RE: **TECHNICAL MEMORANDUM – SUPPLEMENTAL PROPOSED
MODIFICATION OF APPROVED SOURCE CONTROL MEASURES
ODOT FACILITY IN PORTLAND HARBOR PROJECT AREA**

TO: Jonathan Horowitz, PE, ODOT Project Manager
FROM: Kelsey Harpham, WSP Project Manager
SUBJECT: K22552: OF 16-1 and OF 18-2 SCMs
DATE: 19 March 2025

NW Natural 6" Gas
Line

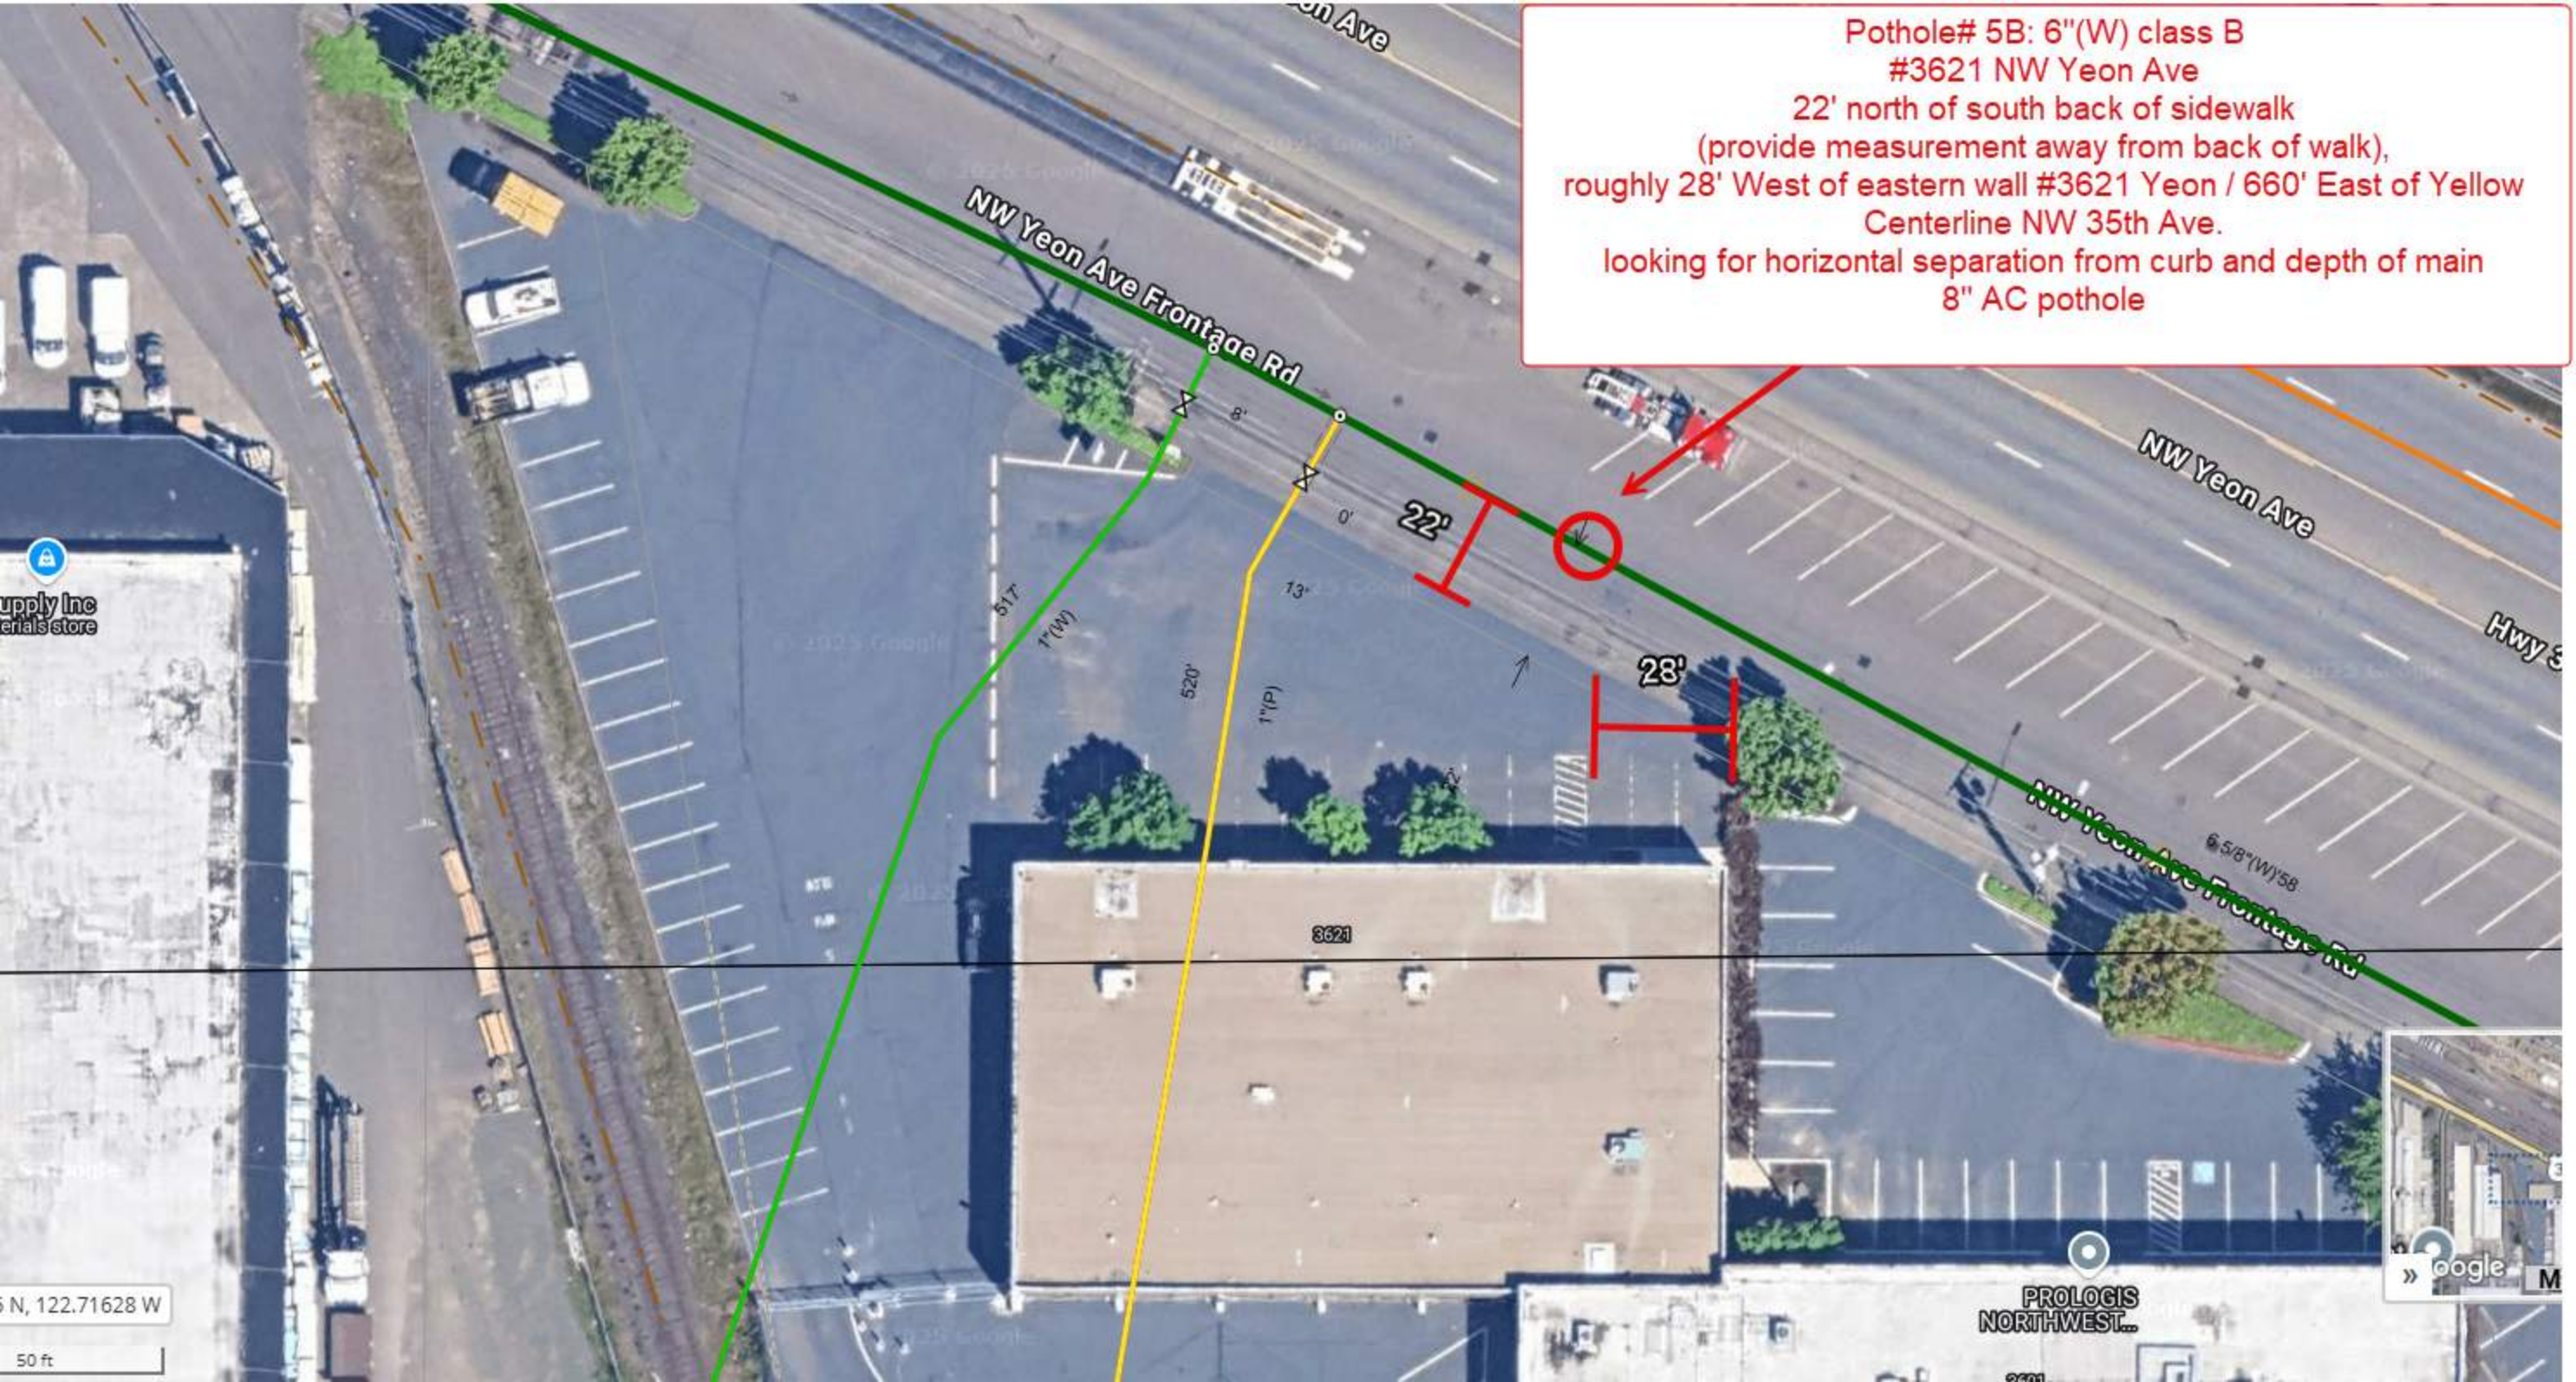
The proposed water quality structure at location 18-2 is one of two water quality structures in the OF 18 basin. The structure at 18-1 is a BioPod which treats 0.55 acres of ODOT area. In the Supplemental FS, the PHS structure at 18-2 was proposed to be located on the south side of US30 on NW Yeon Frontage Road. The project team originally designed the facility near this location. During Draft DAP review, coordination with rail indicated that the rail lines near the proposed location were inactive. However, during Final DAP, further coordination and design review revealed that the nearest rail line to the proposed location was active on a nightly basis. Construction requirements, including permitting, shoring, and flagging, made this location for the facility infeasible. Multiple alternative options were assessed, including:

Based on this analysis, the proposed location in the angled parking area near Prologis NW was evaluated with slightly higher scores than the alternative near the intersection of NW Yeon Ave and NW 35th Ave. The challenges at the site near NW 35th Ave, including utility conflicts and the need for acquisition of ROW, resulted in the slightly lower implementation risk score at this site. There is a slightly higher capital cost for the location near NW 35th Ave, but the treated area is also higher than the location near NW Prologis.

Based on the information provided above, the design team recommends the *removal of the PHS unit at 16-1, and moving forward with design and construction of 18-2 at the location near Prologis NW in the parking area*. The reduction in treated area is low compared to the cost savings and schedule implications of including the sites at either the 16-1 US30 location or at the intersection of NW35th and NW Yeon Ave. This recommendation is based on cost and schedule impacts as well as site constraints.
